**TO:** Mayor Andrew Dickens, City of Atlanta  
**ATTN TO:** Steven Aceto, Urban Planner, City of Atlanta  
**FROM:** Mike Alexander, COO, Atlanta Regional Commission  
**RE:** Development of Regional Impact (DRI) Review

**Name of Proposal:** 680 Spring Street DRI 4321

**Description:** A DRI review of a proposal to construct a mixed-use tower with 627 units and 8,616 SF of retail space on a previously developed 2-acre site at 680 Spring Street in Midtown Atlanta in Fulton County.

SPECIAL ADMINISTRATIVE PERMIT SITE PLAN	
SCALE	1" = 20'
DATE	10/24/2024
DRAWN BY:	MICHAEL WIRSHAT
PROJECT ENGINEER:	JEFFREY PHILLIPS
QA/QC REVIEWER:	QA/QC REVIEWER

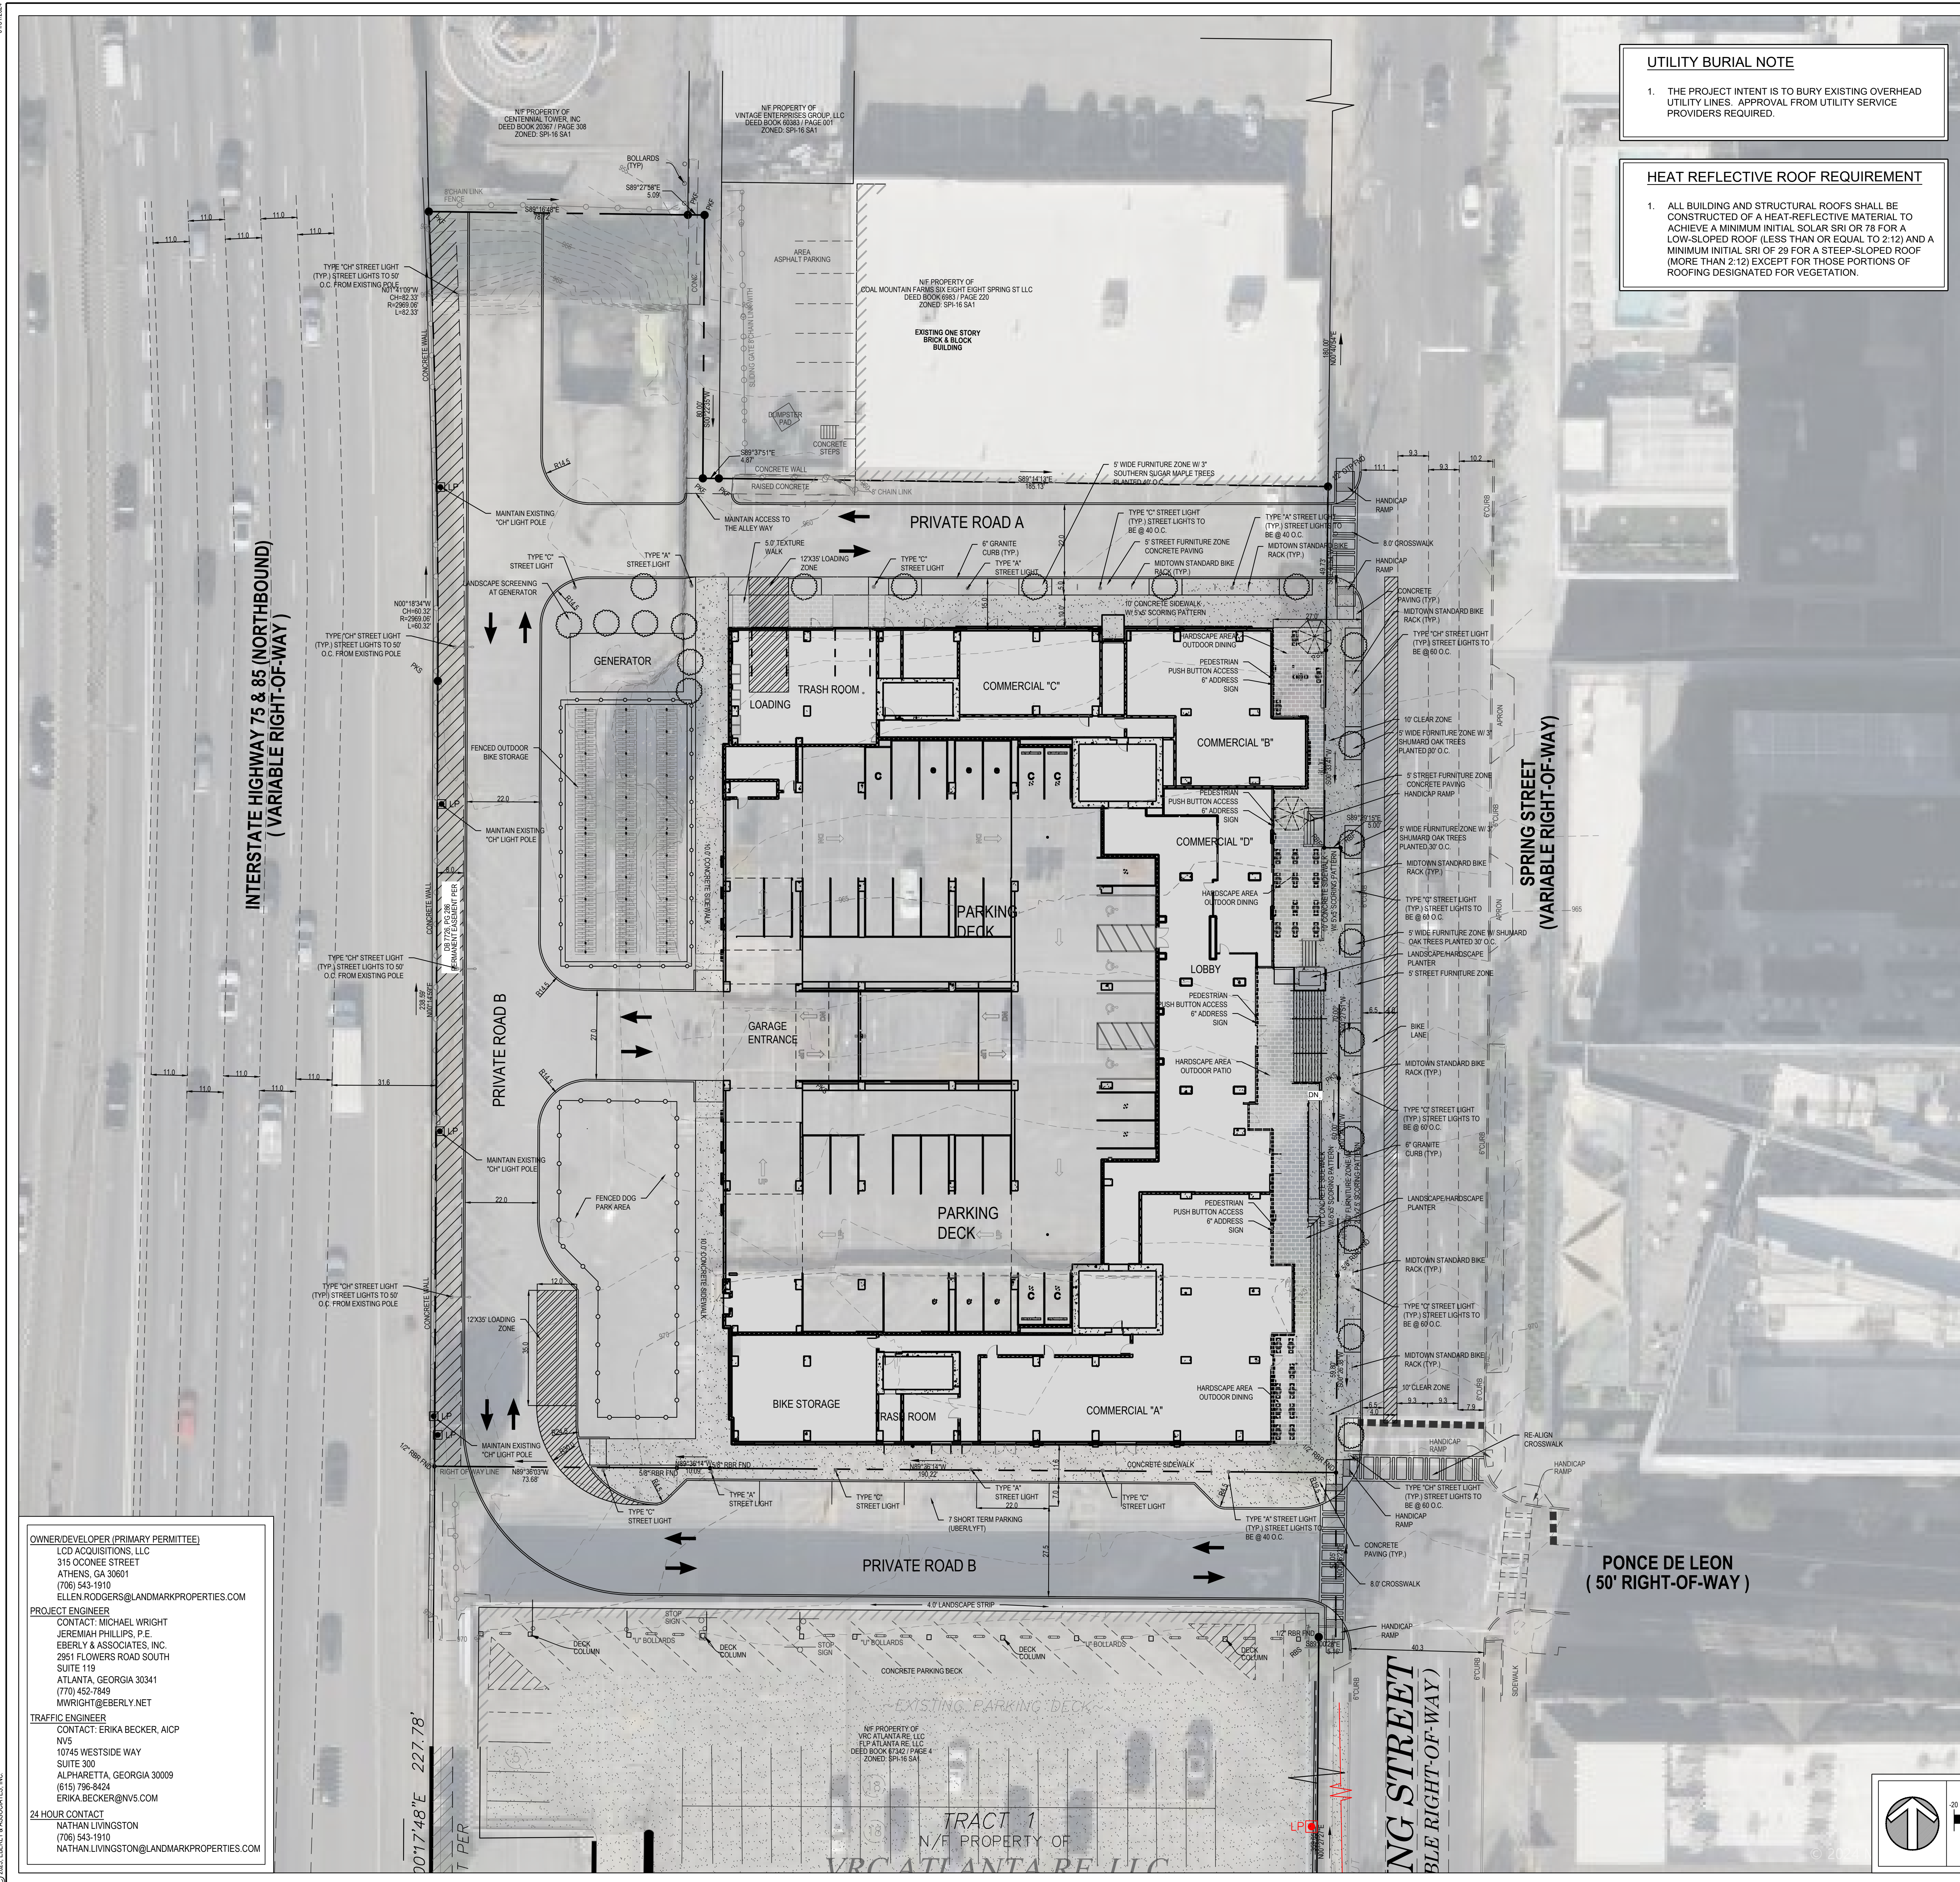
Care should be taken to ensure that the constructed development provides an interconnected, functional, clearly marked, and comfortable pedestrian experience on all driveways, paths, entrances, and parking areas. To the maximum extent possible, new driveways and intersection corners where pedestrians will cross should be constructed with minimal curb radii to reduce speeds of turning vehicles and decrease crossing distances for pedestrians.

Yes, the site provides safe and convenient pedestrian and bike access. A possible improvement could be speed bumps to slow traffic coming in and out of the deck on private roads A and B.

- Add a crosswalk connecting the southwest and southeast corners of Spring St NW & Ponce de Leon Ave NW so that all four legs of the intersection are marked.
- Add a raised buffer or vertical elements separating the bike lane from the vehicular lanes.
